DELEGATED DECISIONS BY CABINET MEMBER FOR TRANSPORT MANAGEMENT

CHESTERTON: PROPOSED 20MPH & 40MPH SPEED LIMITS

Report by Corporate Director, Environment and Place

Project title
Chesterton 20mph

Drawing title
General Layout

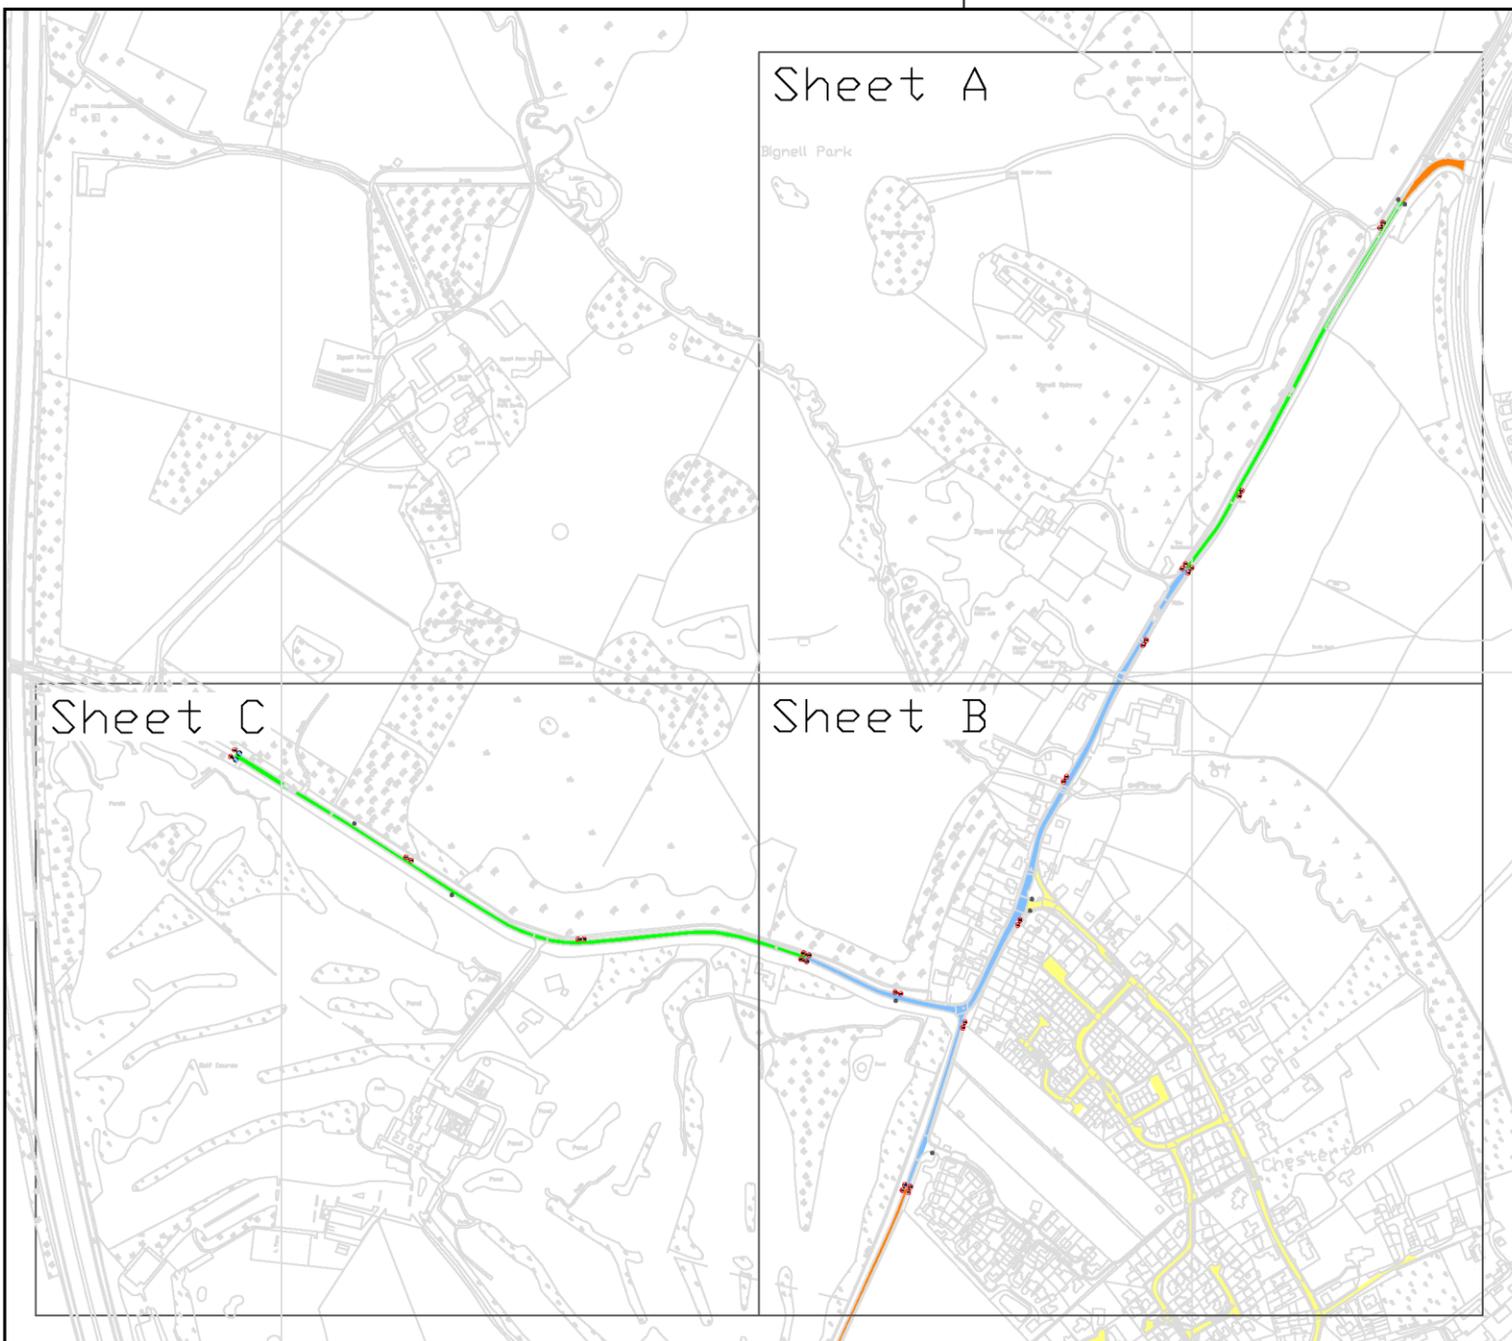
- Thames Valley Police objected to the proposals based on poor compliance in neighbouring parishes such as Kirtlington. They were concerned that current consultation follows previous ones, citing that previously the A4095 had not been considered, and failed to see justification for it to be included this time. The lack of evidence or history of recent collisions was used to question the proposals and asked that it remained at 30mph. They also re-iterated their views concerning OCC's policy and practice regarding 20mph speed limits.

- Oxford Bus Company offered no formal objection; however they drew attention to the proposed extensive development of land to the south & west of the village, and that the delivery and operation of potential new routes servicing these may well be affected by the proposals, and would make it harder to offer the frequency of service the Council has required within reasonable resource requirements.

RESPONDENT	COMMENTS
<p>(1) Traffic Management Officer, (Thames Valley Police)</p>	<p>Object – Based on poor compliance in neighbouring parishes. I use Kirtlington as an example. I am also aware this is now the 3rd consultation on 20 limits from this parish. Previously the A4095 has not been considered and I fail to see the justification for it now. There is no evidence or history of recent collisions to justify and ask that it remains at 30.</p> <p>Thames Valley Police welcome the opportunity to engage on plans for road safety improvement and acknowledge that 20mph limits can be a useful tool in road safety. There are other reasons 20mph limits may be desirable for communities, such as environmental concerns, and creating a shared space environment to encourage greater diversity of road users.</p> <p>Compliance with 20mph limits is a challenging issue as there is a difference between the achievable results of the various available schemes. For example a sign-only scheme will only have a limited effect on the mean speeds, as opposed to other schemes that influence the road environment, which is recognised as being key to achieving compliance. If a speed limit is set too low and is ignored then this could result in the vulnerable road user being less safe. It can also cause a disproportionate number of drivers to criminalise themselves and could bring the system of speed limits into disrepute.</p> <p>Thames Valley Police have no policy to enforce based on arbitrary speed limits alone but will enforce based on threat of harm, risk and resourcing. 20mph limits are not excluded from this and will be enforced where appropriate. There should be no expectation that the police would be able to provide regular enforcement if a speed limit is set too low as this could result in an unreasonable additional demand on police resources and there are no additional resources available to support extra enforcement. Messages from partners that police will not enforce need to be discouraged. Such messaging can encourage non-compliance and should be avoided.</p> <p>The policy of Thames Valley Police is to use sound practical and realistic criteria (Setting local speed limits - GOV.UK (www.gov.uk)) when responding to Highway Authorities in an effort to promote consistency and to reduce the burden of constant and unnecessary enforcement. The advice shown in Circular Roads 1/2013 states.</p> <p>The key factors that should be taken into account in any decisions on local speed limits are:</p> <ul style="list-style-type: none"> • history of collisions • road geometry and engineering • road function • composition of road users (including existing and potential levels of vulnerable road users)

(4) Local resident, (Chesterton)	<p>Object – I am a long time resident of Chesterton and I wish to object to any extension of the existing 20 mph. The residential area of the village is covered by the 20 mph and that is more than enough. The only area of concern is The Hale which should have a pavement and the limit be reduced to 30mph.</p> <p>My reasons are that councils should use common sense and not reduce speeds to far too low a level for people to move around at a reasonable speed. I do not wish to live with Welsh restrictions.</p>

<p>(9) Local resident, (Chesterton, Kirtlington Road)</p>	<p>20mph – No objection Happy with 20mph through Chesterton</p> <p>40mph – Object The speed limit of 40mph should go back to the motorway bridge on the Kirtlington Road into Chesterton. As the owner of Bignell Park Barns, a number of the people who work here come to work on bicycles and this would make the road safer.</p>
